SERVICE BULLETIN

#0010

SUBJECT: Amendment to the Sling 2 and Sling 4 Series Annual Inspection

PURPOSE: To inspect Rib 601 within the airframe for material thickness and Cracks.

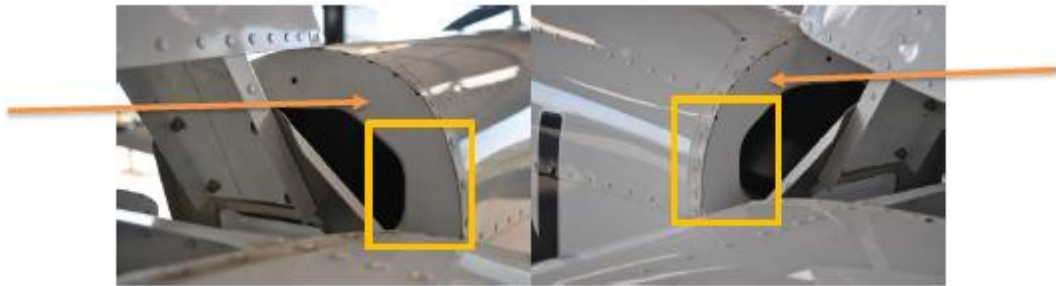
1. With reference to the below pictures, the areas within the yellow boxes on Rib 601 need to be inspected. On Airplane models affected Rib 601 should first be measured for material thickness. If the rib material thickness measures 0.64mm the Service Bulletin needs to be complied with. With a material thickness of 0.8mm this Service Bulletin no longer needs to be complied with. An entry should be made in the logbook stating the Rib 601 meets the material thickness requirement and no further action is necessary.

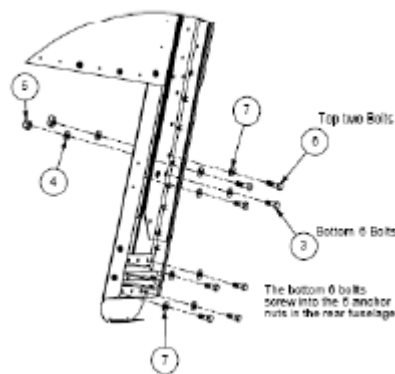
6. Once the two rudder cables have been removed, push the rudder over to either the left or right, this will enable you to loosen the three rudder hinge bolts using 3/8" spanners.
7. Using the two 3/8" spanners, loosen the three rudder hinge bolts so as to remove the rudder from the vertical fin.
8. With reference to the below picture, loosen all four bolts using the two 3/8" spanners.

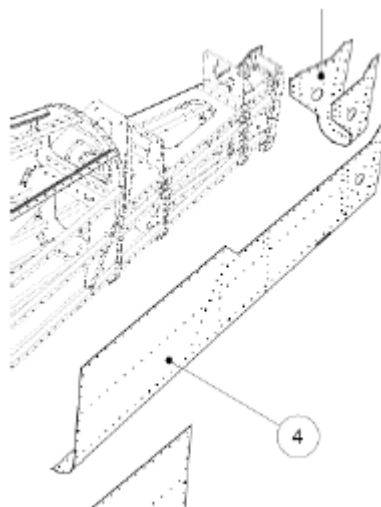
9. Remove the vertical fin so that the bolts that attach the horizontal stabiliser can be removed.
10. When looking from the back of the aircraft onto the vertical fin, the 8 bolts that attach the rear spar of the vertical fin need to be removed in order to remove the vertical fin. The picture below illustrates which bolts to remove. Before removing these bolts ensure the strobe light wire is disconnected.

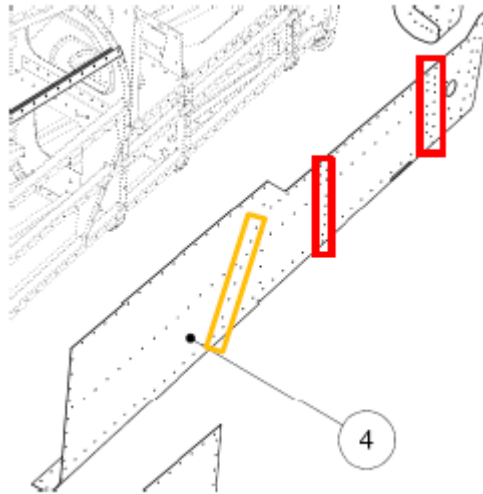
14. Once skin (4) has been removed from the fuselage, follow the line of rivets that attach rib 601 to the rest of the fuselage, de-rivet all these rivets using a 3.2 mm drill bit and pneumatic drill.
15. With reference to the below picture, follow the line of rivets illustrated in the yellow box, de-rivet all these rivets using a 3.2 mm drill bit and pneumatic drill. It should be noted that this has to be done on both sides of the fuselage. The line of rivets should flow from top to bottom going from the rear of the aircraft to the front of the aircraft in a diagonal direction. Once all the rivets that attach the rib and bracket to the fuselage have been removed, the rib and bracket should be easily removed.

20. Rivet each hole with 3.2 mm domed aluminium rivets. It should be noted that with reference to the above picture, the rivets in the red boxes should be rivets of 4 x 10 mm domed aluminium rivets, the exact place of these rivets can be found with reference to the rib 601 & bracket assembly instruction page, and these parts are labelled 3 & 4.

Figure 6: Rib 6 assembly

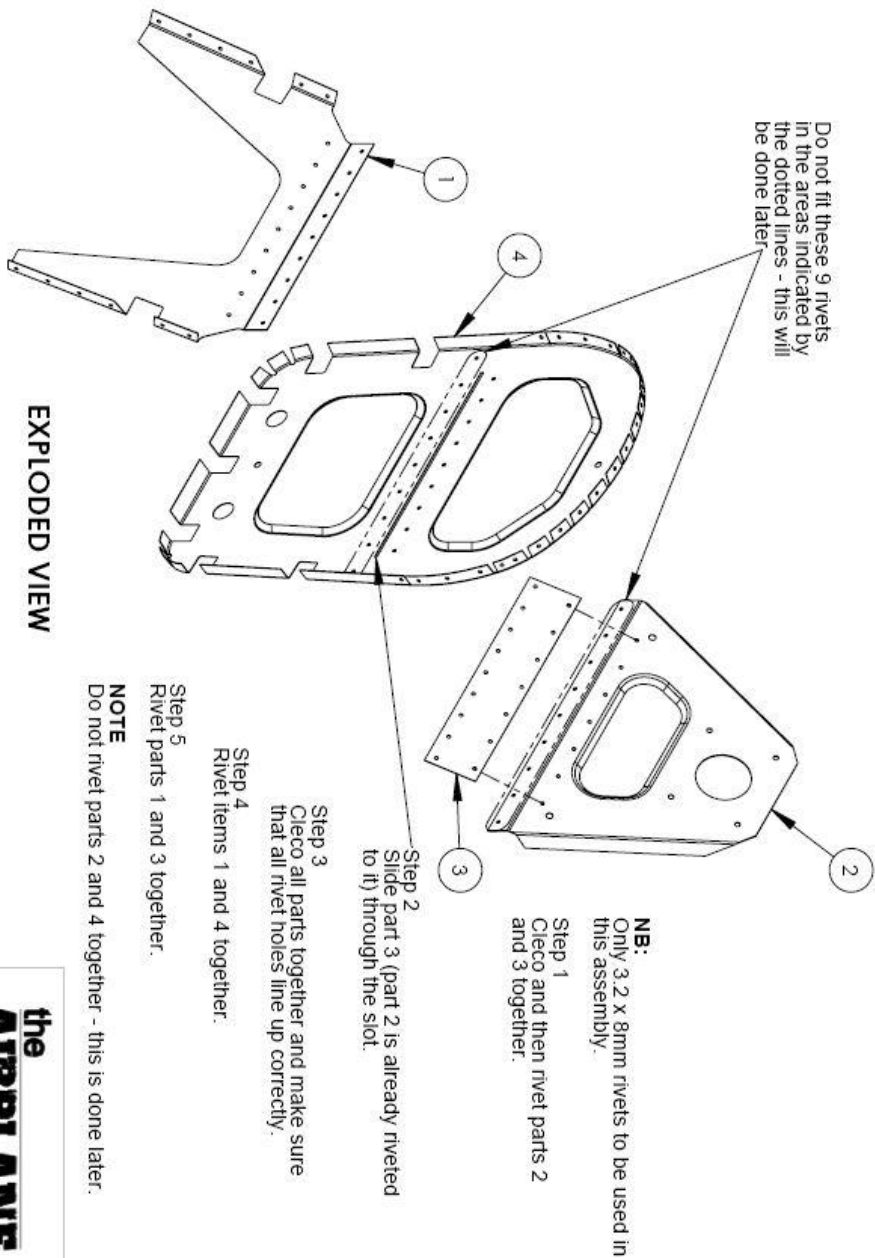
16. It should be noted that the ribs removed from the aircraft should be scrapped and never used on an aircraft again.
17. Once the new part have been assembled with reference to the rib 601 & bracket assembly page, place them in the fuselage as the previous parts were positioned.
